# Addendum

**Project:** Harris County Psychiatric Center Renovation  
Units 1C, 2E, 3B, 3C, 3D, & 3E

**Addendum No.:** 002

**Date:** November 14, 2016

ISSUE FOR BID  
**FIRST FLOOR FINISH PLAN - UNIT 1C**

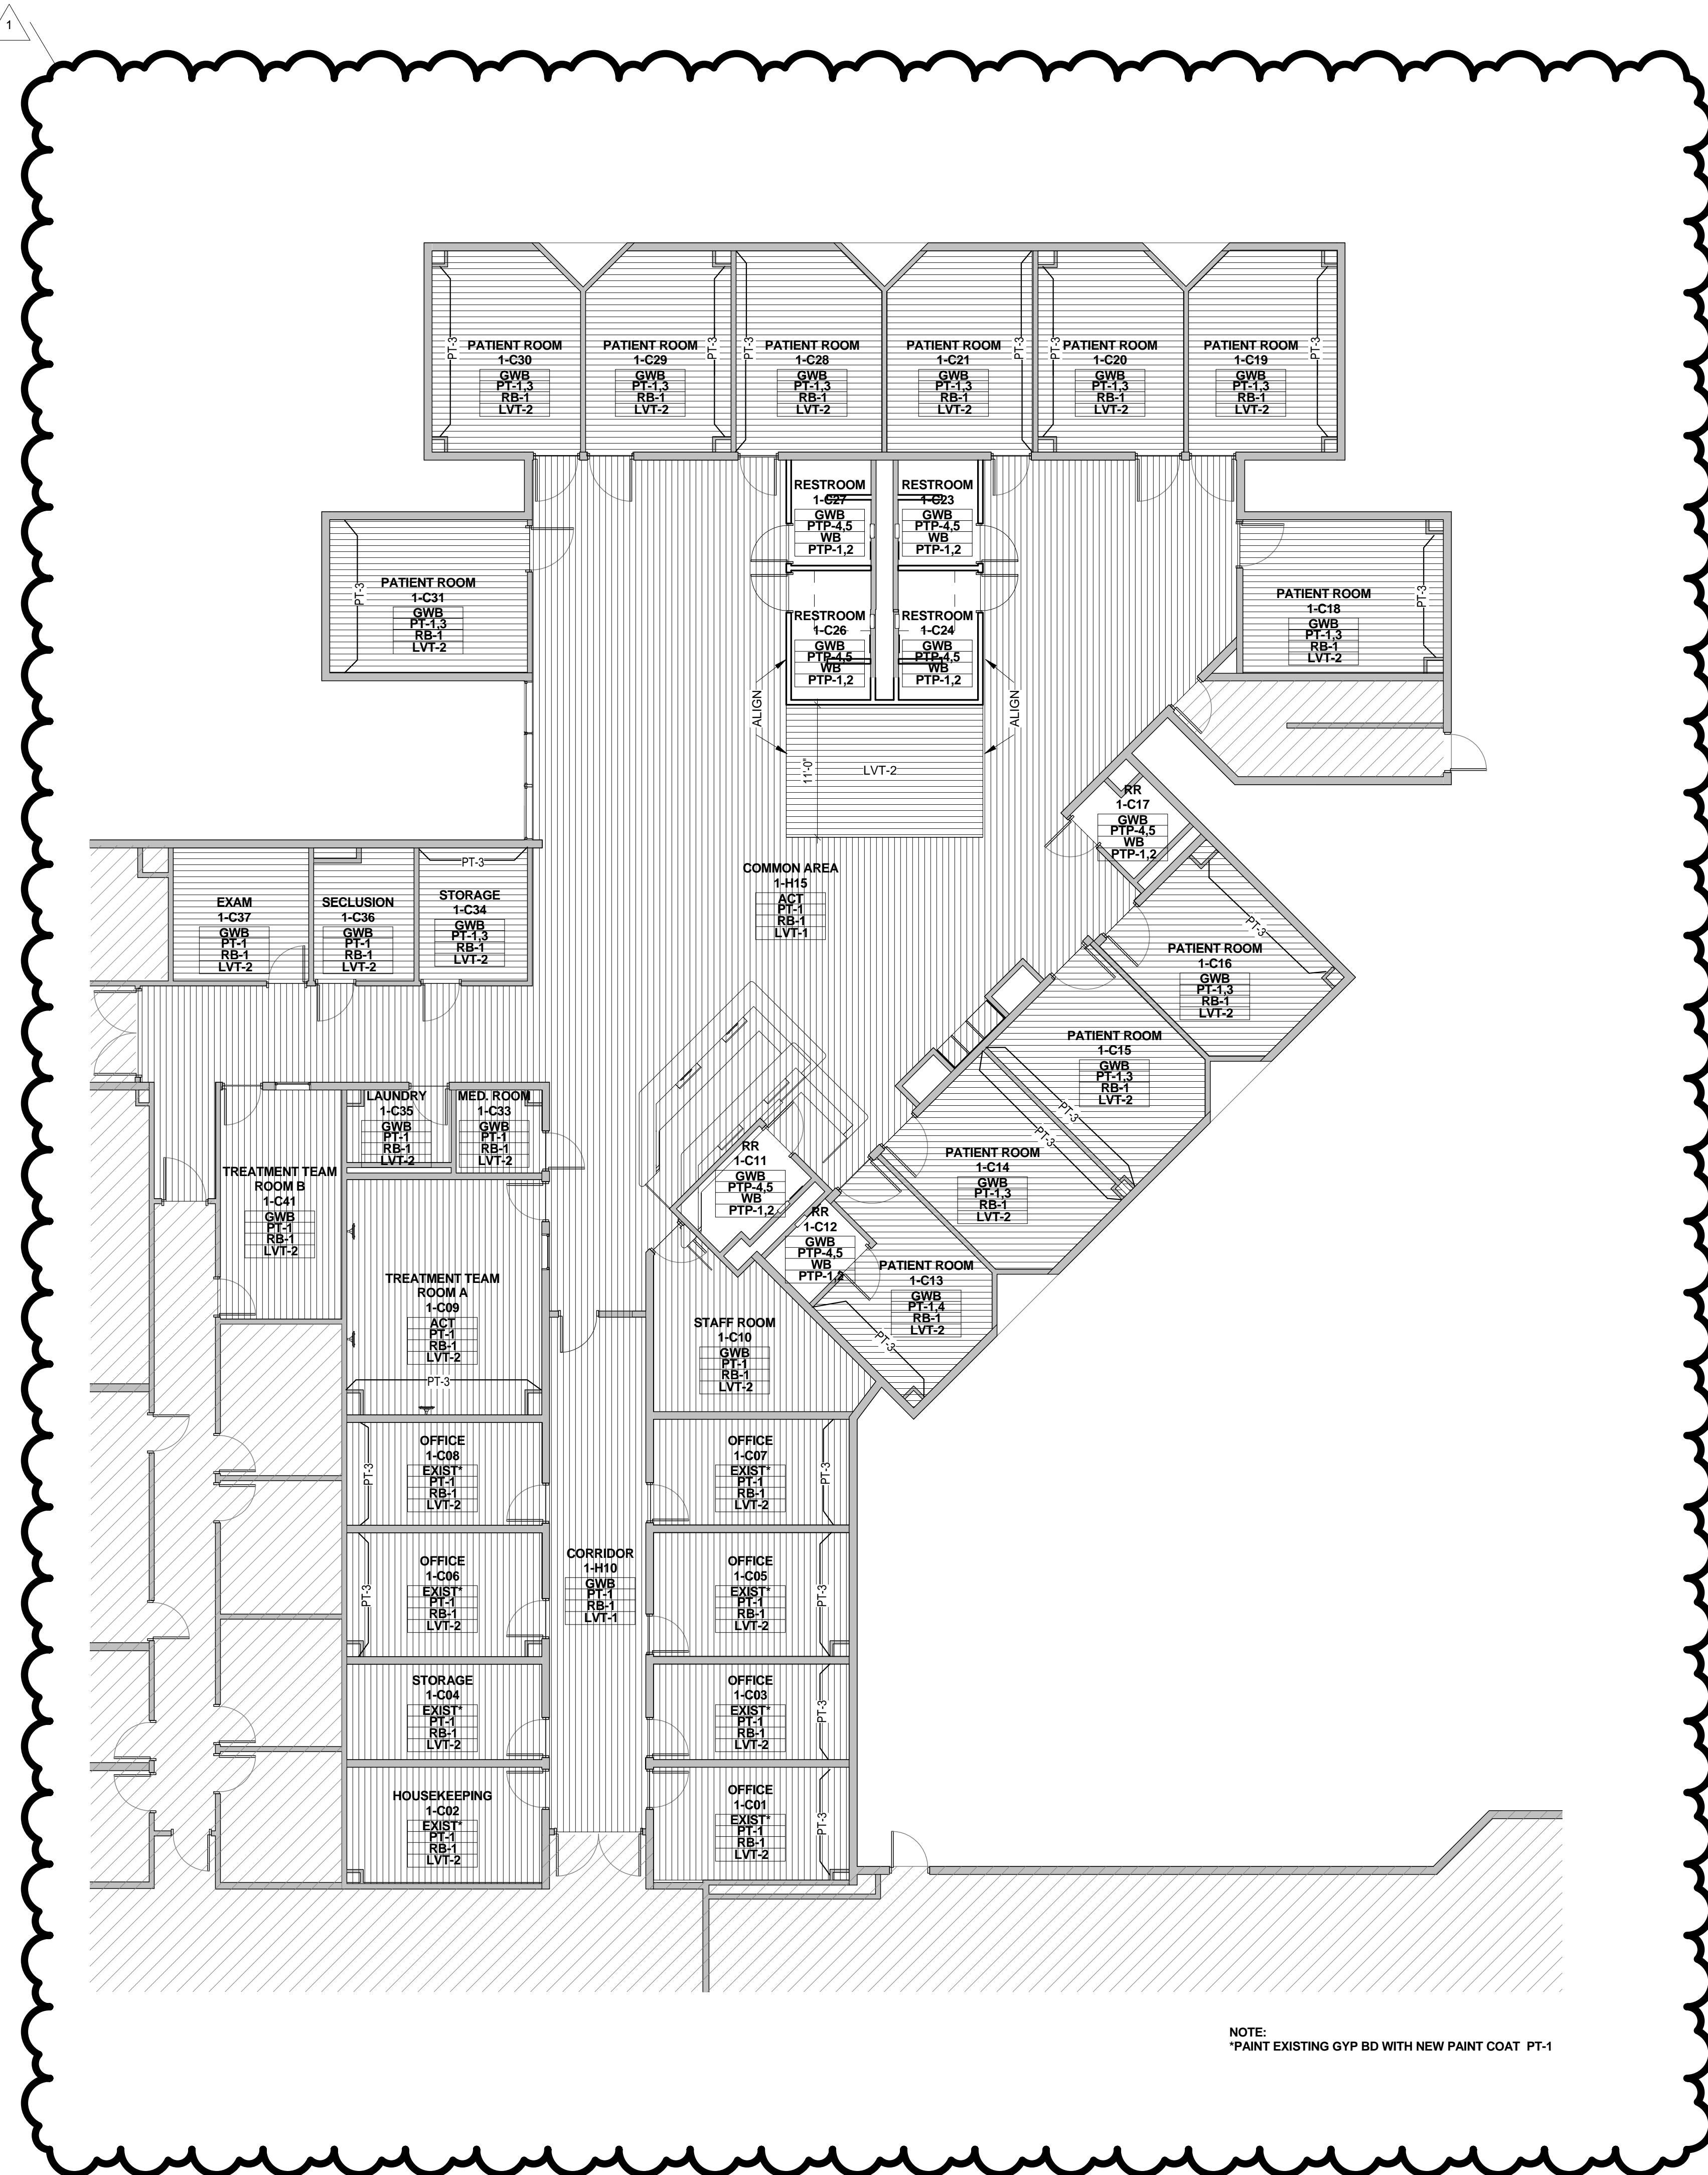
6. Sheet A2.08B, Third Floor Unit 3B, revised to reflect changes to keyed notes on demolition and/or renovation plans. (see attached)
7. Sheet A2.19C, First Floor Finish Plan – Unit 1C, revised to reflect changes to LVT-1 flooring specification and addition of flooring pattern(s) and grain direction(s) in Common Area. (see attached)

ISSUE FOR BID  
**THIRD FLOOR FINISH PLAN - UNIT 3E**

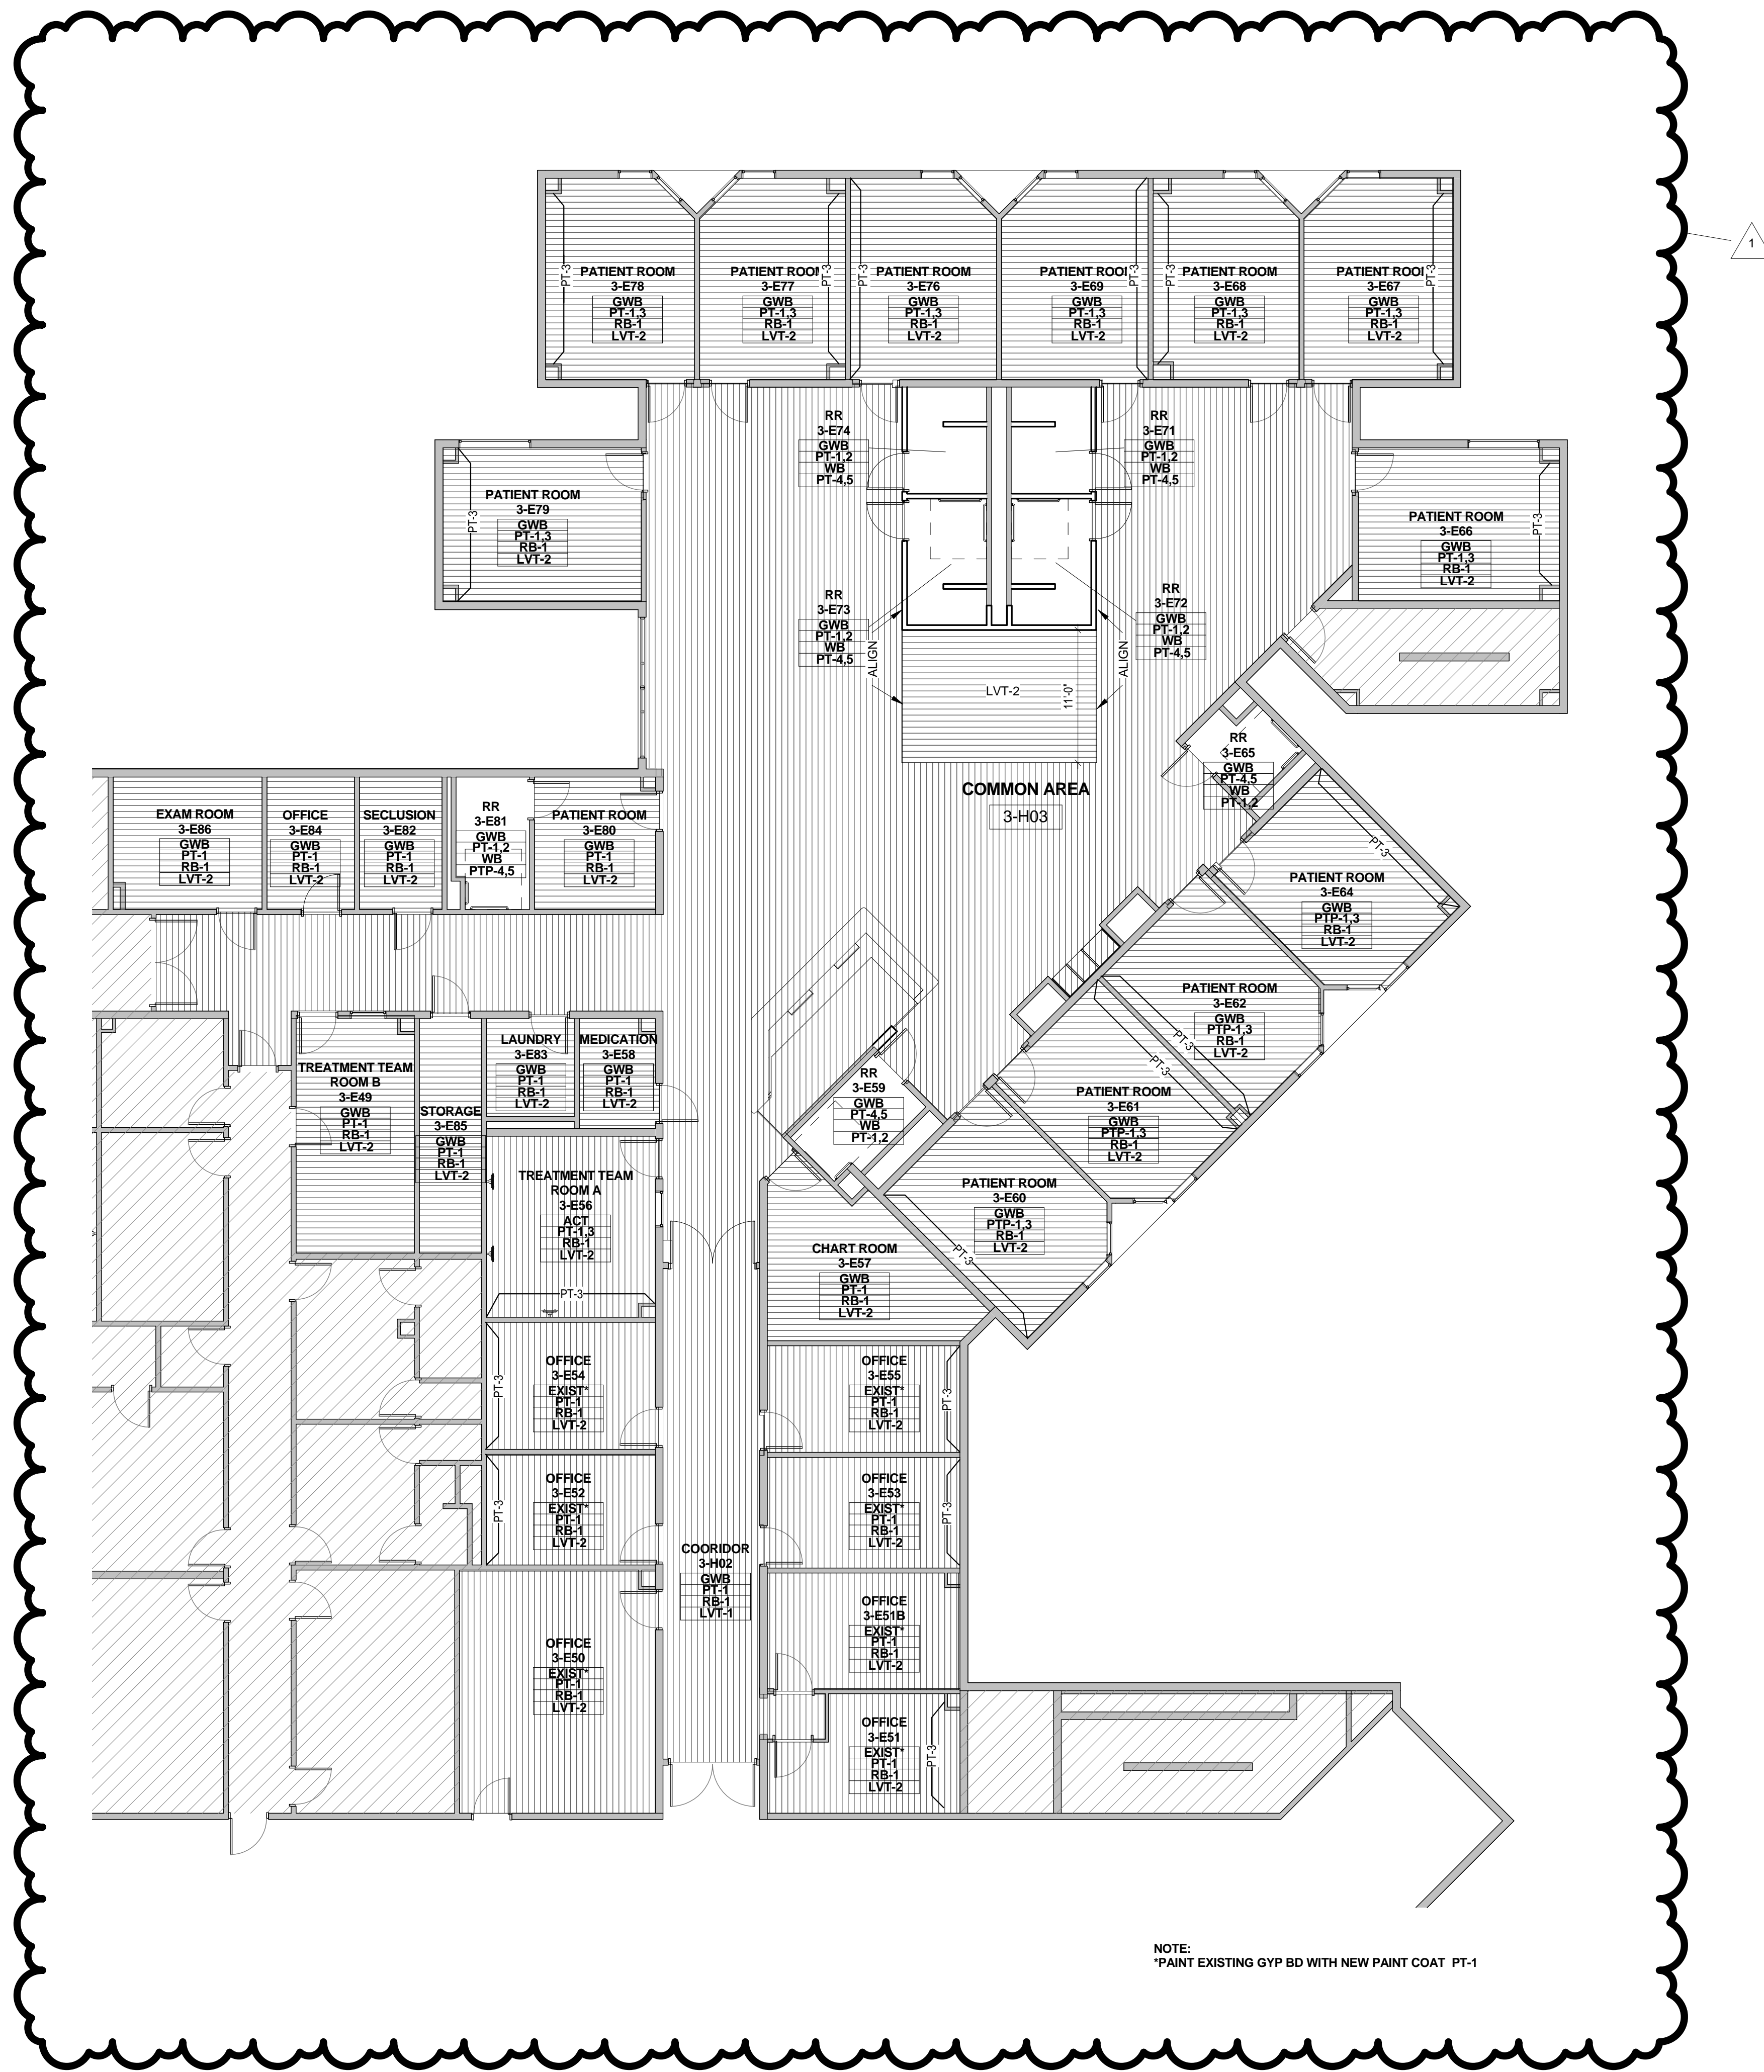
12. Sheet A2.24E, Third Floor Finish Plan – Unit 3E, revised to reflect changes to LVT-1 flooring specification and addition of flooring pattern(s) and grain direction(s) in Common Area. (see attached)
